Planning Commission Staff Report

Consideration of a Preliminary Plat application for the Diamond Fields Subdivision Plat “A”, a 3-lot residential subdivision located at approximately 590 East 1000 North in the RA-2 Zone.

MAPLETON CITY DEVELOPMENT REVIEW COMMITTEE MINUTES

On November 12, 2019, Donald Bleggi submitted new plans for the 3 lot Diamond Fields Subdivision in the RA-2 zone and located at approximately 650 East 1000 North. The items below include 1) requested changes to the submitted plans, 2) other items required as part of the application and/or 3) informational items regarding city standards. **All items that include an * and are bolded are required prior to any public hearings.**

DIAMOND FIELDS SUBDIVISION SITE PLAN

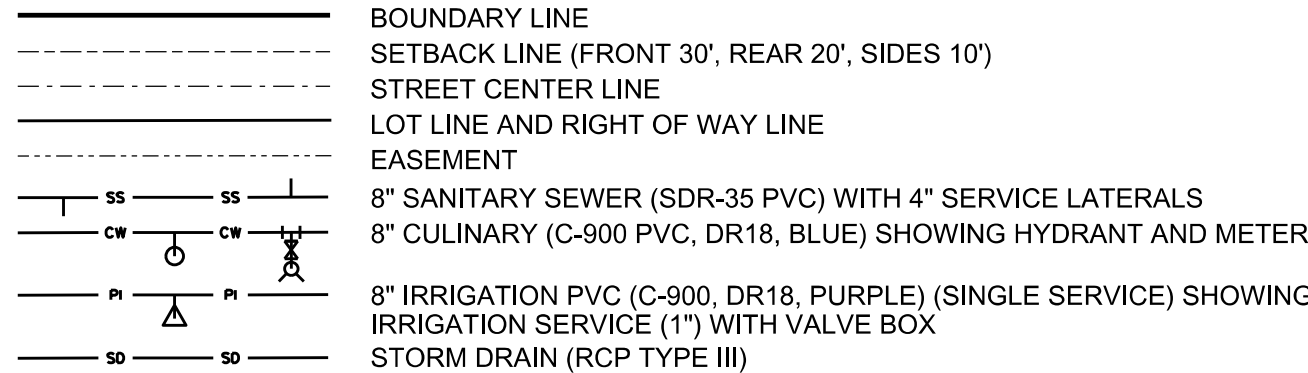
1. The final plat must include, among other requirements, the following:
 - a. A signature block for the Planning Commission Chair to approve the plat. **The "Director Secretary" approval line is not needed.**

- b. A signature block for the City Engineer to approve the plat. **The "City Utilities Approval" signature block is not needed. Mapleton Irrigation is the only utility that will be required to sign the plat.**

- c. Addresses must be shown on the final plat.
 - d. Street coordinates must be shown on the plat.
 - e. In accordance with the standards of the Utah County Recorder, a space must be reserved near the bottom right hand corner for the recording certificate to be printed on the plat. The current plat doesn't make space for this certificate. Please communicate with the Utah County Recorder's Office for the specifics for this requirement.

- f. In accordance with the standards of the Utah County Recorder, the names of the Owners must be printed in the Acknowledgement as the persons who appeared before the notary. It is useful for the plat to contain a space within the acknowledgment text for the names to be written. Other standards may apply for trusts and corporations.

2. The assigned addresses for this plat are: **Lot 1 - 491 East 1000 North, Lot 2 - 593 East 1000 North, and Lot 3 - 594 East 1000 North.** Please label the lots accordingly.
3. The setback information on the plat is incorrect. Please remove.
4. The area to be dedicated, the public street, must be more obviously designated as the dedicated area. Often some sort of cross hatch with a note in the legend is used.

1. Please use ductile iron for culinary water main.

1. Pre-Treatment sumps shall include an oil adsorbent pillow. See attached standard detail.

1. Remove reference to 1" slurry seal
2. 8" road base required per city standard cross section, including under sidewalk
3. Cross slope on 1000 N must be between 0% and 4% where new curb is placed.
